TSGT#22(04)0167 page 1 of 2

Title: 2nd batch of TTCN CRs to TS 34.123-3 v.3.6.0 and v.3.6.1 for

approval

Change 2

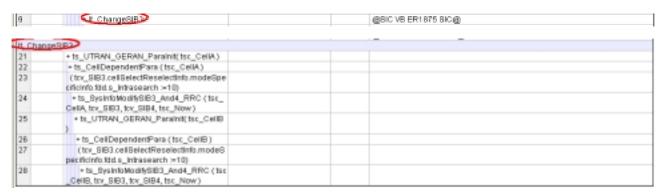
Test step	tc_9_4_2_4_2
Reason for change	In this test case one IE is changed in SIB3; as this IE is not omitted in SIB4, this SIB needs to be changed the same way.
Summary of change	test step lt_ChangeSIB3 renamed to lt_ChangeSIB3and4 (when used and when specified) change applied to SIB3 applied to SIB4 as well
Source of change	new change

Test step name Tc_8_2_2_4 : It_LocalTest

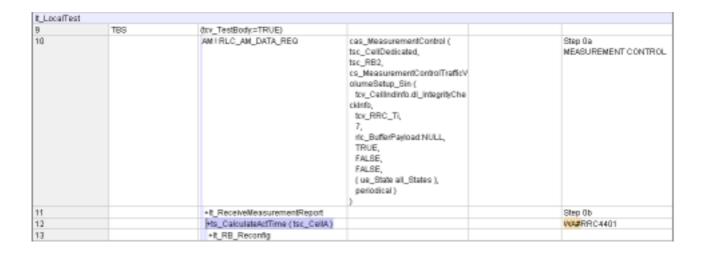
Reason for change The activation time must be calculated just before the RB reconfig message is

sent

Summary of change Removed the activation time test step before meas control message and

Test step name Tc_8_2_2_4: lt_RB_Reconfig

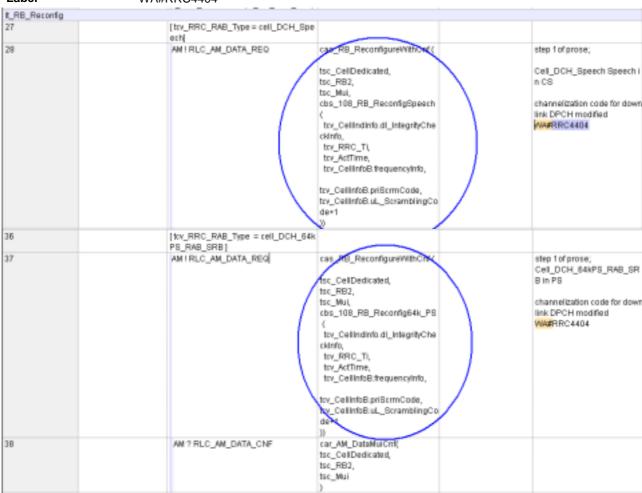
Reason for change The original RB reconfig message would not trigger a Radio Bearer

reconfiguration failure message. Since there are no physical channel modification the UE would reconfigure the RB and send out RB reconfig complete message. The SS will not receive this message as the DL-DPCH channelisation code is modified. This would result in no RB reconfig failure

message after the cell update confirm message

4.8 ts_SendRB_SetUpConvSpeech_12_2k_InteractBackg_64k (WA#RAB4488)

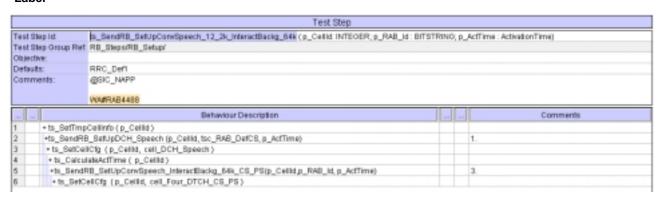
Reason for change Inconsistency with approved CR 041172. The security procedure in steps B9

and B10 were move before the RAB setup procedure for PS (implemented in

4.11 ts_SendRB_SetUpConvSpeech_InteractBackg_64k_128k (WA#RAB4488)

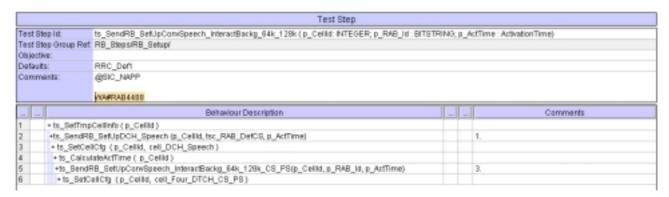
Reason for change Inconsistency with approved CR 041172. The security procedure in steps B9

and B10 were move before the RAB setup procedure for PS (implemented in

4.3 c_DCH_336_TFS_23c_DL_40 and c_DCH_336_TFS_23c_UL_40 (WA#RAB4218)

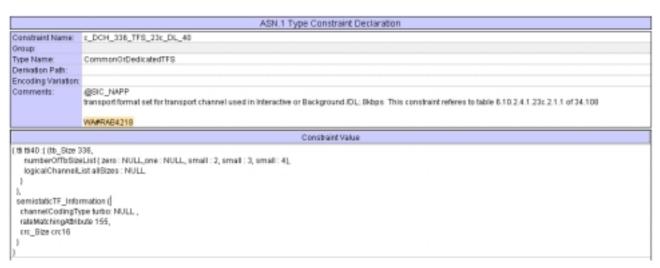
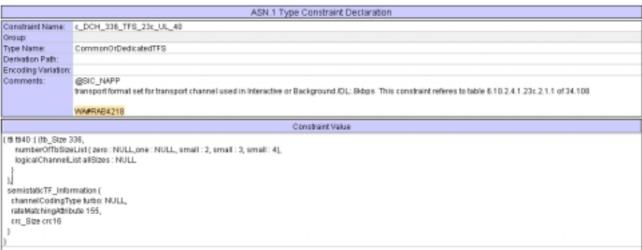
Reason for change Wrong channel coding type: it should be "turbo" coding instead of

"convolutional 1/3".

4.6 ts_ReceiveFirstSDU_RB10_RB11_RB12_RB20 (WA#RAB4321)

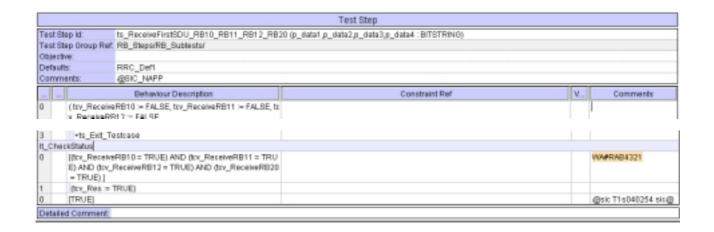
Reason for change TTCN error, wrong control variable for RB20.

Summary of change Used tcv_ReceiveRB20 instead of tcv_ReceiveRB12 for RB20.

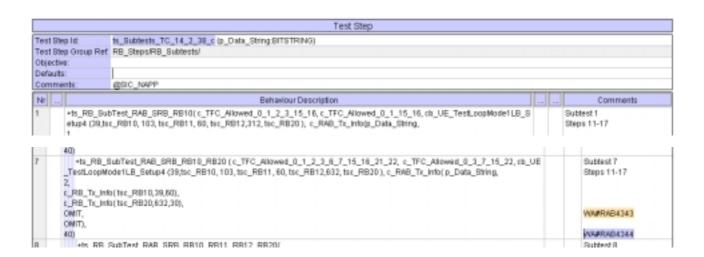
Reason for change TTCN errors for subtest 7: wrong number of Data SDUs to be looped back for

RB20 (it should be 30 instead of 60) and wrong maximum TTI value (it should

be 40 ms not 20).

Summary of change Corrected the number of Data SDUs to be looped back for RB20

4.6 ts_ReceiveFirstSDU_RB10_RB11_RB12_RB20 (WA#RAB4321)

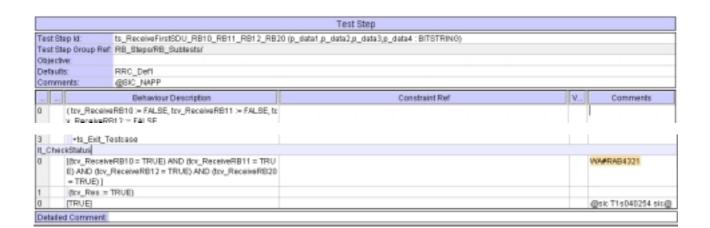
Reason for change TTCN error, wrong control variable for RB20.

Summary of change Used tcv_ReceiveRB20 instead of tcv_ReceiveRB12 for RB20.

4.9 ts_Subtests_1_14_TC_14_2_38f (WA#RAB4454)

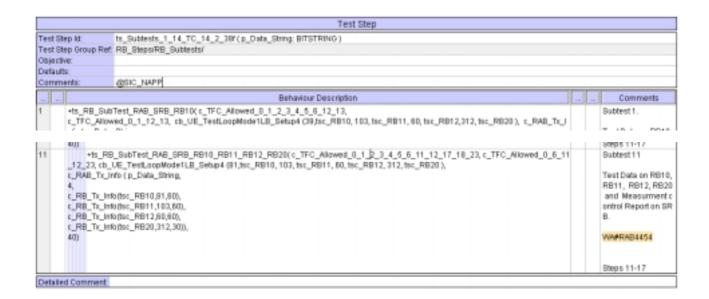
Reason for change TFCS 6 for DL necessary in subtest 11.
